THE MARYLAND-NATIONAL CAPITAL PARK & PLANNING COMMISSION

MEMORANDUM

SUBJECT: Final Water Quality Plan for Clarksburg Village – Site Plan # 8-03002

Re: **Final Water Quality Plan for Clarksburg Village-
Phase I**
SM File #: 200006
Preliminary Plan No.: 1-01030
Tract Size, Zone: 333 Ac., R-200/TDR-4,
R-200/TDR-3, R-200 and PD-4
Tax Plate: EW, EV, FV 123 and FV 122
Watershed: Little Seneca Creek

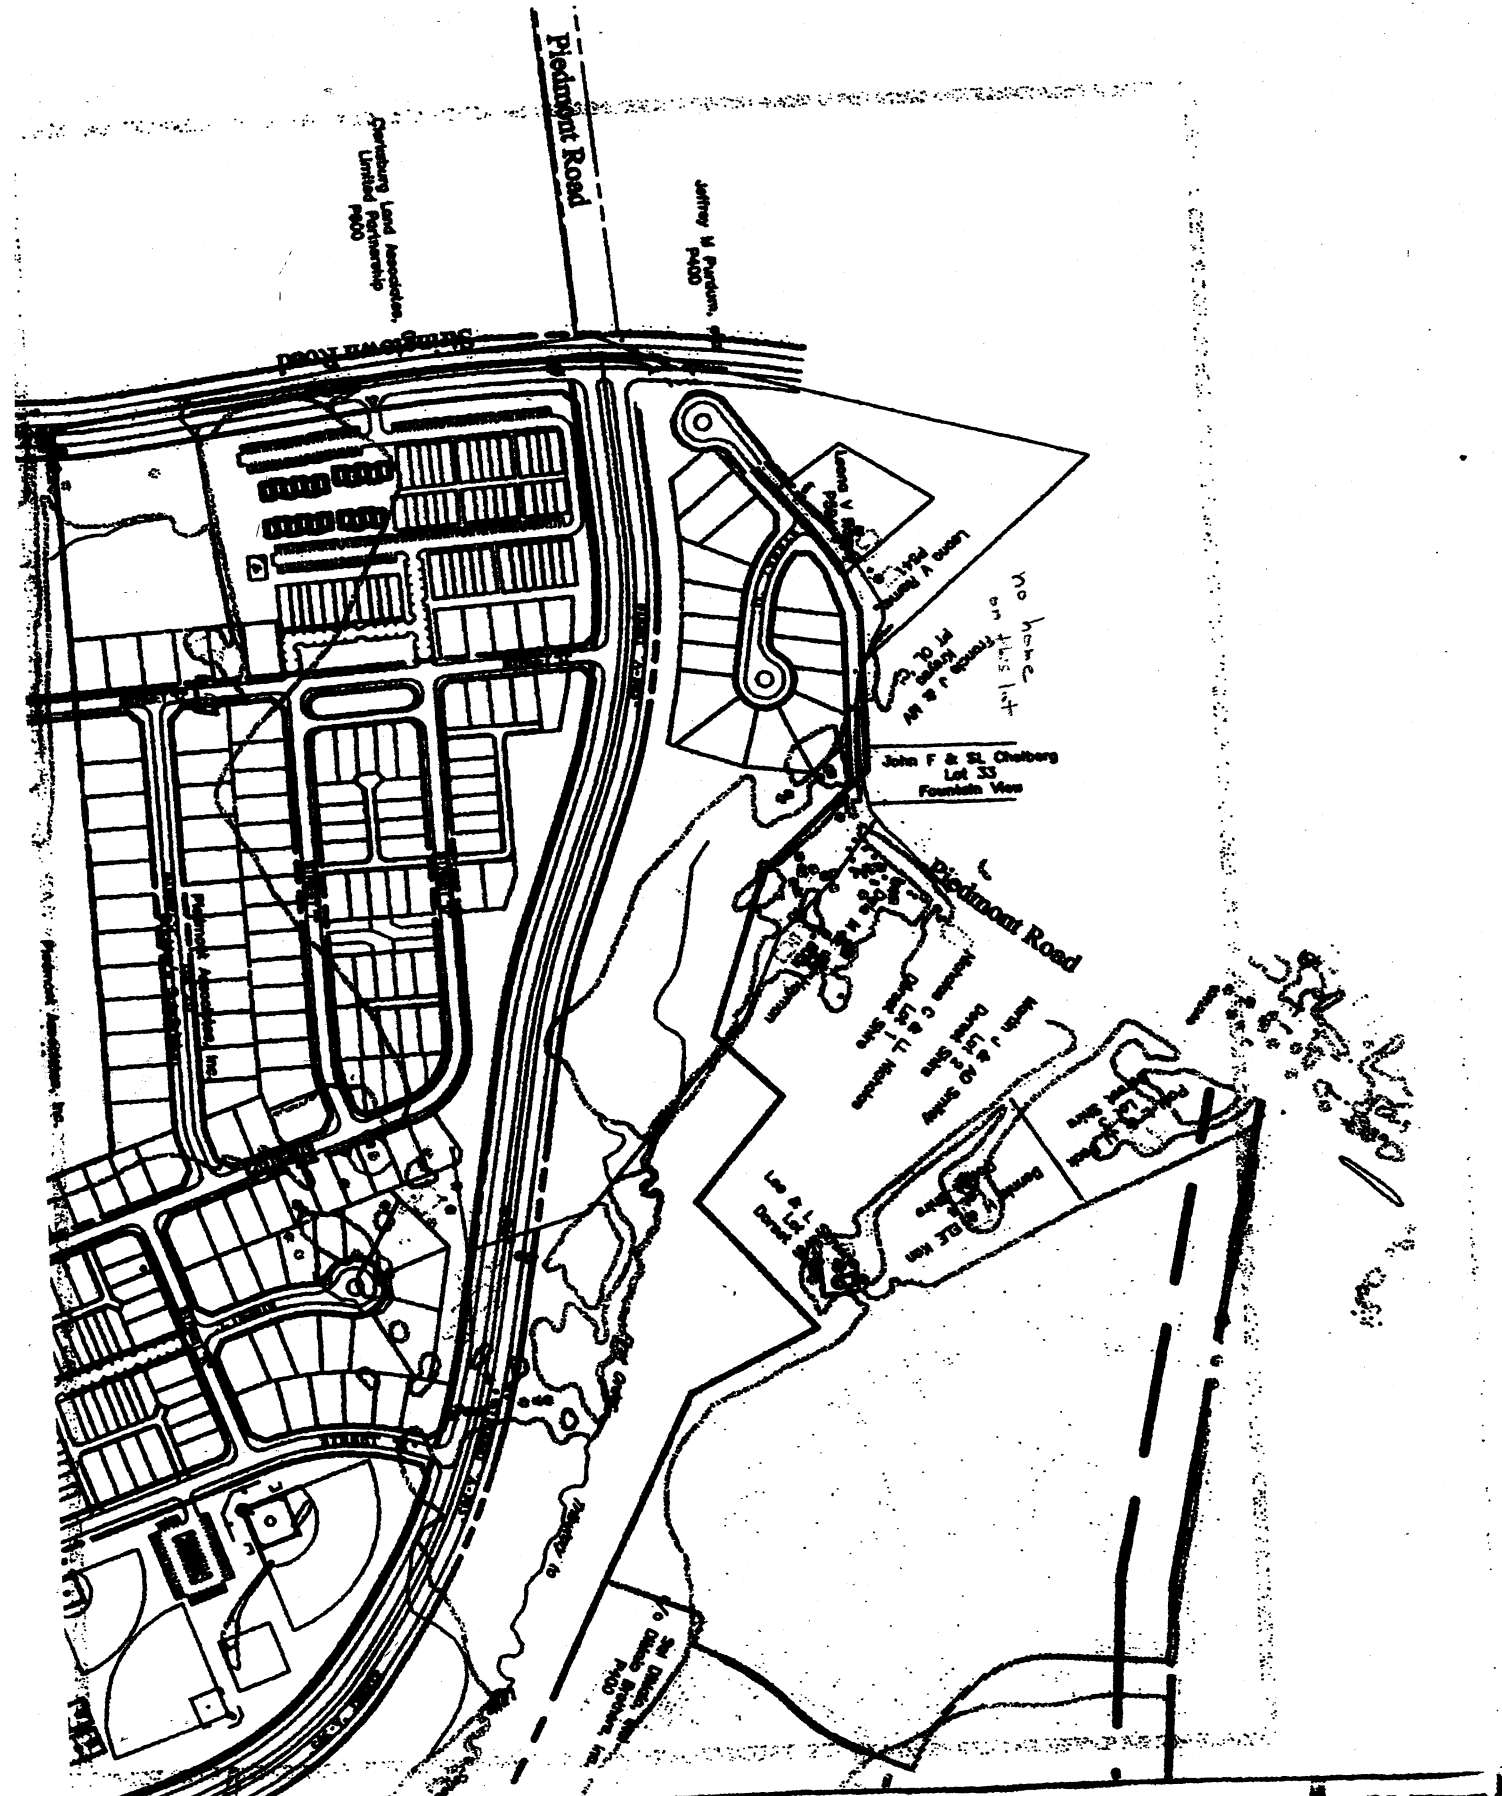
We the undersigned Piedmont Road property homeowners, would like to see the section of Piedmont Road referenced in the attached drawing end in a court and not connect to A-305. As Piedmont Road has been designated a rural, rustic road, we feel having the road end in a court rather than attached to a major arterial road would better preserve its existing character, thereby allowing it to remain in keeping with the intent of the rural designation.

We have attached a copy of Mr. Flanagan's preliminary site plan for our section of Piedmont Road with the end of Piedmont changed to a court. This concept represents our vision for Piedmont Road.

We are writing in reply to your letter/petition received on September 18, 2001 suggesting that the section of Piedmont Road, a rustic road, approaching Stringtown Road and proposed A-305 end in a cul-de-sac, and not connect to either road.

Planning staff involved in Community-Based Planning, Subdivision Development Review, Site Plan Review, as well as Transportation Planning have reviewed your request. It is staff's consensus that the connection of Piedmont Road to A-305 as approved in the preliminary plan for Clarksburg Village is essential to provide connectivity of local neighborhoods and to provide opportunities for local circulation of vehicular and pedestrian traffic within the community. Therefore, staff does not support your idea to terminate Piedmont Road in a cul-de-sac approaching Stringtown Road or A-305.
